**City of Portland, Maine - Building or Use Permit Application**

Permit No: 07-0675	Issue Date:	CBL: 379 D005001
-----------------------	-------------	---------------------

Past Use: Single Family Home	Proposed Use: Single Family Home - build a 44' x 7' Country Porch	Permit Fee: \$90.00	Cost of Work: \$6,073.00	CEO District: 5
Proposed Project Description: Build a 44' x 7' Country Porch		FIRE DEPT: <input type="checkbox"/> Approved <input type="checkbox"/> Denied	INSPECTION: Use Group: Type:	
		Signature:	Signature:	
PEDESTRIAN ACTIVITIES DISTRICT (P.A.D.) Action: <input type="checkbox"/> Approved <input type="checkbox"/> Approved w/Conditions <input type="checkbox"/> Denied Signature: Date:

<b>Dept:</b> Zoning	<b>Status:</b> Denied	<b>Reviewer:</b> Ann Machado	<b>Approval Date:</b>
<b>Note:</b> Not meet front setback & over lot coverage. Tried to work with owner to have it meet zoning but it didn't work out. Owner would like their money back.			<b>Ok to Issue:</b> <input type="checkbox"/>
<b>Dept:</b> Building	<b>Status:</b> Pending	<b>Reviewer:</b>	<b>Approval Date:</b>
<b>Note:</b>			<b>Ok to Issue:</b> <input type="checkbox"/>

SITE PLAN  
SCALE 1/16" = 1'-0"

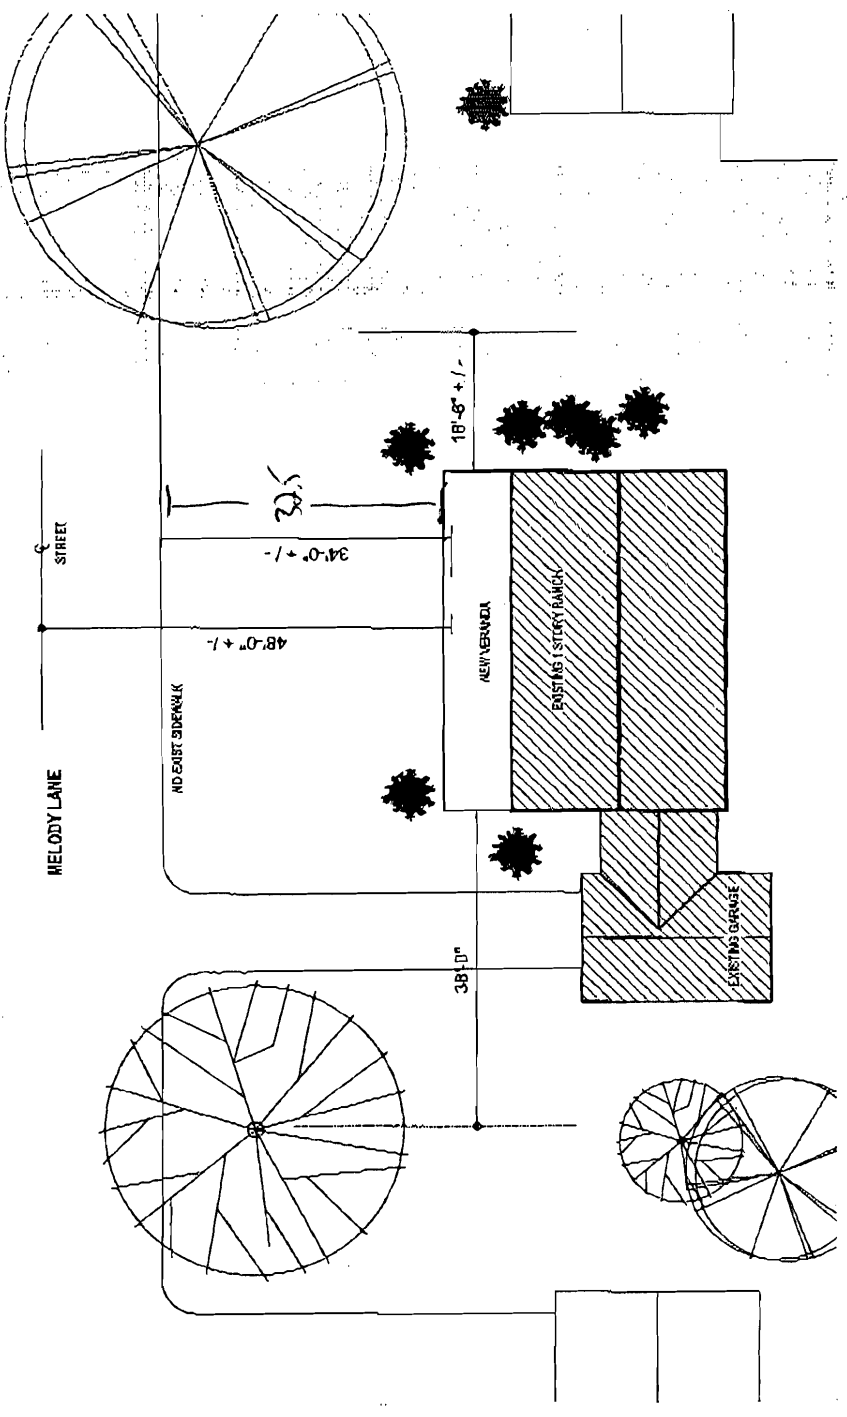
<b>Comments:</b>
8/15/2007-amachado: Met with Debbie Harmon. Explained to her that she doesn't have the front setback to build a 42' x 7' farmer's porch because there is only 4.5' between the front of the house and the 25' front setback. . She could use section 14-425 to come out 6' and make the porch 33' long which would meet the 50 sf requirement. The steps would have to come off the side. With a 6' x 33' porch and steps she would also be over lot coverage by about 25 sf so part of the rear deck would have to be removed. She might file a practical difficulty appeal. I told her to let me know what her decision is.
6/8/2007-ldobson: hold for payment
6/14/2007-dmartin: Payment recieved, routed permit to Zoning/dm
6/14/2007-amachado: Left message for Robert Ingerowski, contractor. Addition does not meet lot coverage although the plot plan does not show the deck. Question about front setback. It says 32' from street, but it also gives the centerline of the street and the proposed porch is only 46' from the centerline.

6/15/2007-amachado: Spoke to Robert Ingerowski. Explained to him how the proposed porch is over the allowable lot coverage and my concern that the porch would not meet the front setback. He said that he would get back to me.
9/24/2007-amachado: Received voicemail from Debbie Harmon. Wants to withdraw permit. I left her a message saying that she needed to send us something in writing requesting her maoney back.

28' view street if 10' r/w 12' - 28' from CL to porch 46.5

Farmer's porch could be 6' x 33' if steps come off to side & w/in 25' setback
